SERVICE BULLETIN

CABIN DOOR AJAR SWITCH BRACKET REWORK

- A. Aircraft Affected: All McDonnell Douglas Helicopter Systems (MDHS) MD900 Series Helicopters, serial numbers 00008 thru 00051.
- B. Assembly/Components Affected by this Notice: LH and RH Cabin Door Ajar Switch Brackets 900E2750155-103, 900E2750155-105, 900E2750156-103, 900E2750156-105, JE-1 Switch Actuators, and JE-12 Switch Actuators.

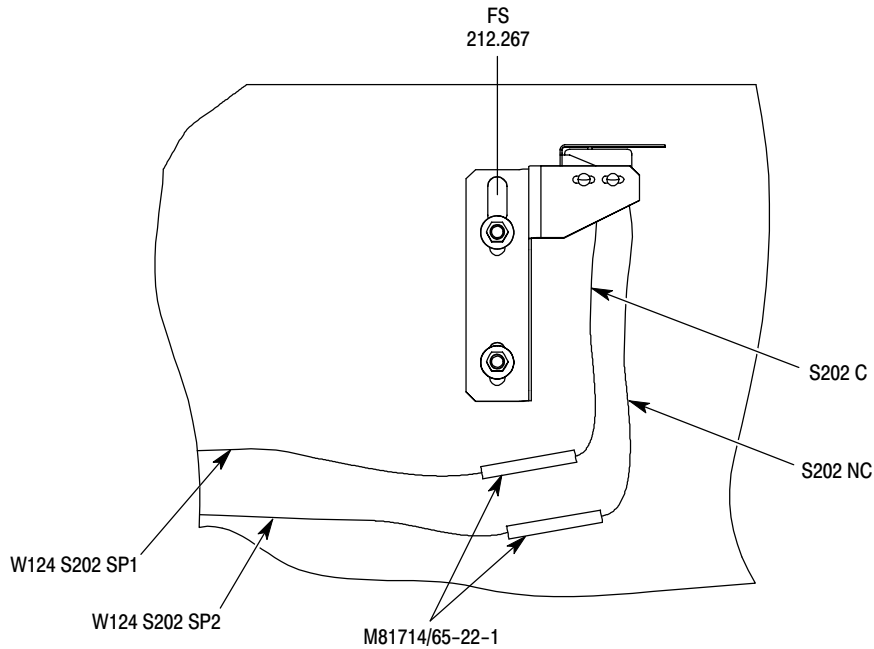
F. Connect existing LH wires W125 S201, SP1 to S201 C and W125 S201, SP2 to S201 NC (Ref. Figure 1).
